Justification for Class III Permit Modification March 2006 SWMU 140 Operable Unit 1295 Building 9965 Septic System and Drywell (Thunder Range)

Justification for Class III Permit Modification

**REQUEST FOR SUPPLEMENTAL INFORMATION
RESPONSE AND PROPOSAL FOR
CORRECTIVE ACTION COMPLETE
DRAIN AND SEPTIC SYSTEMS SWMU 140,
BUILDING 9965 SEPTIC SYSTEM**

ATTACHMENT C
ER SITE 140
REVISED FIGURES 1-1 AND 1-2

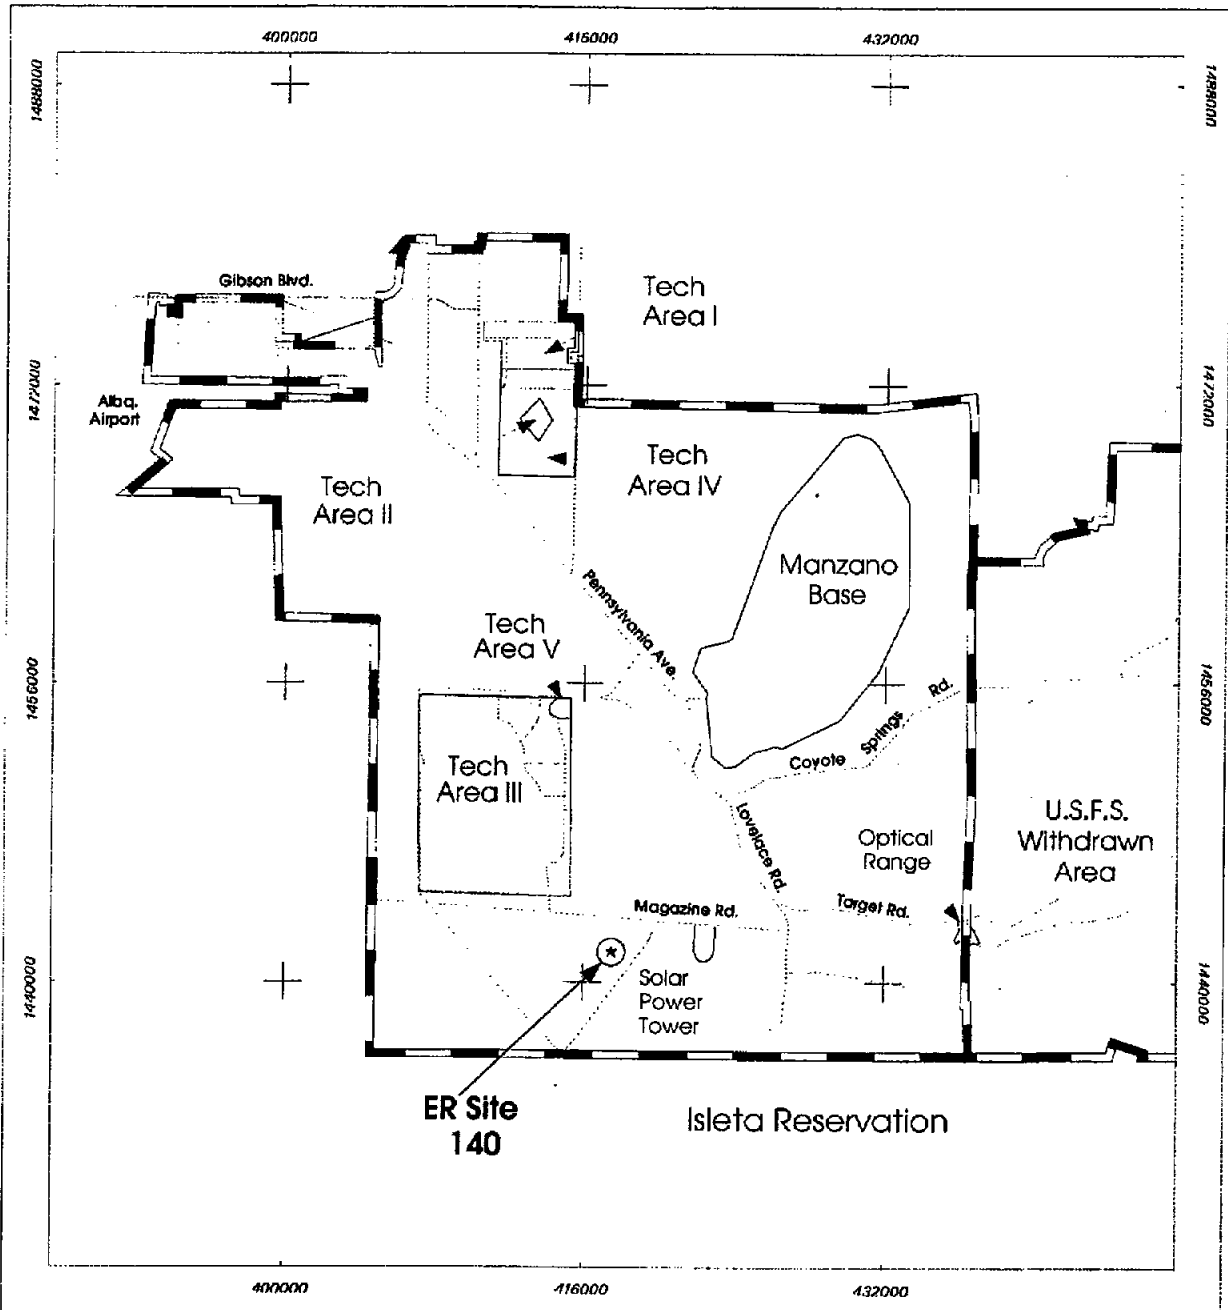
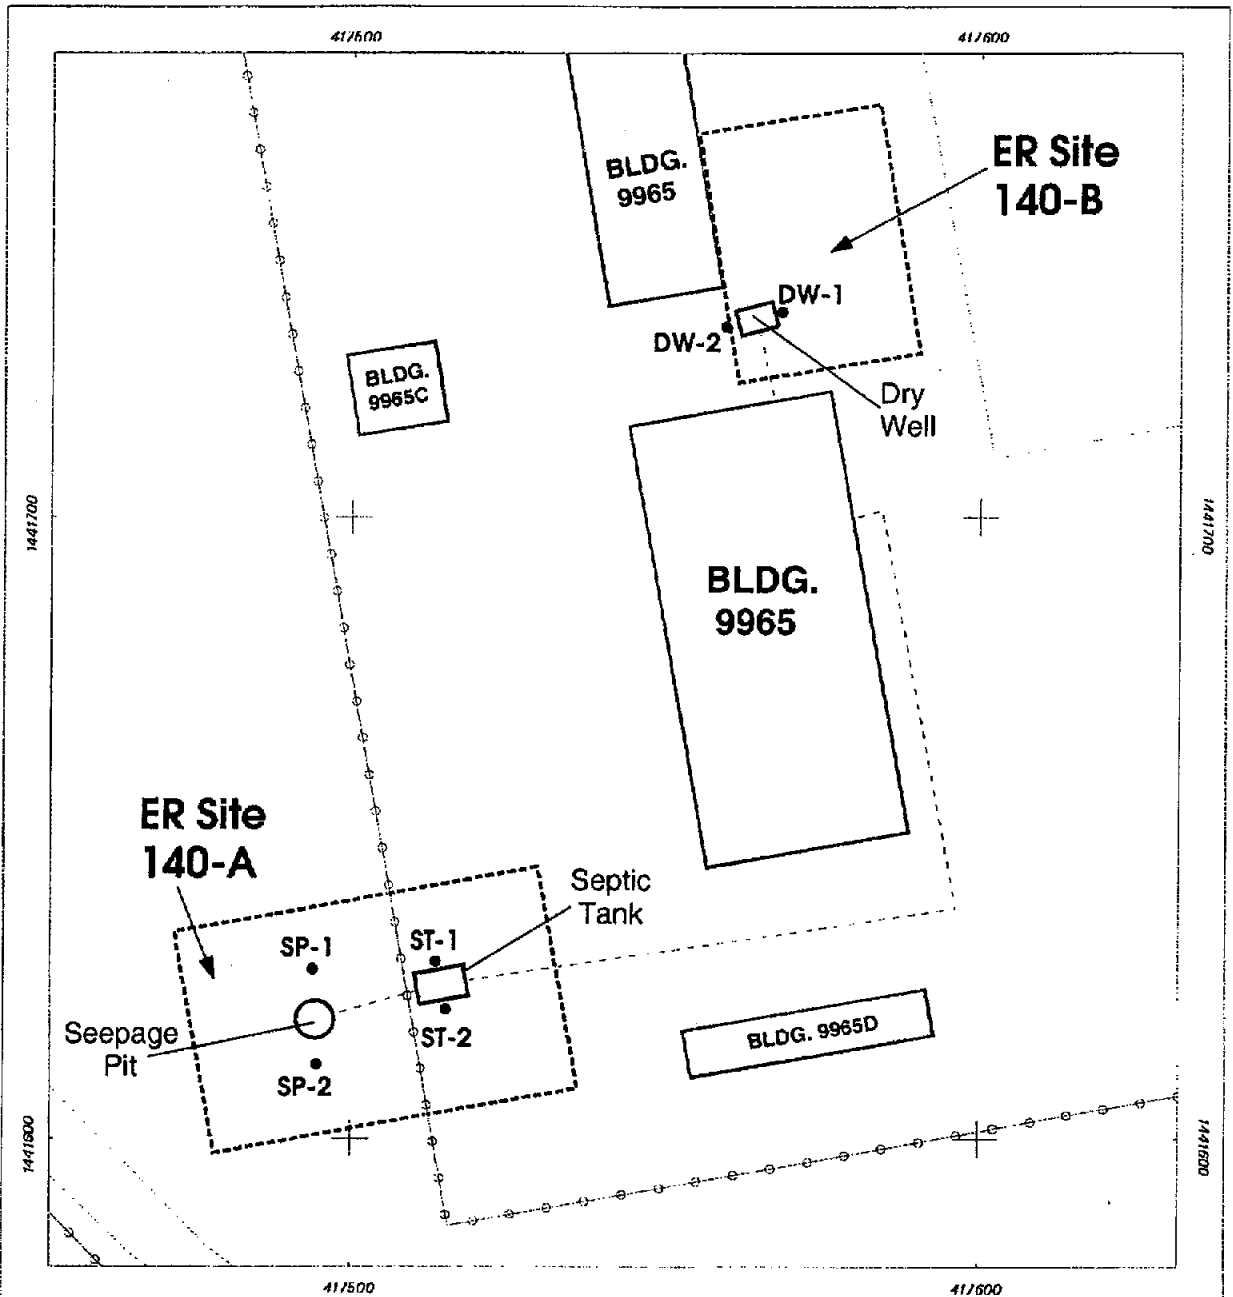
1. **The maps shown in Figures 1-1 and 1-2 are labeled "draft". See general comment 1.**

Response: Replacement Figures 1-1 and 1-2 without the word "draft" are provided in Attachment C.
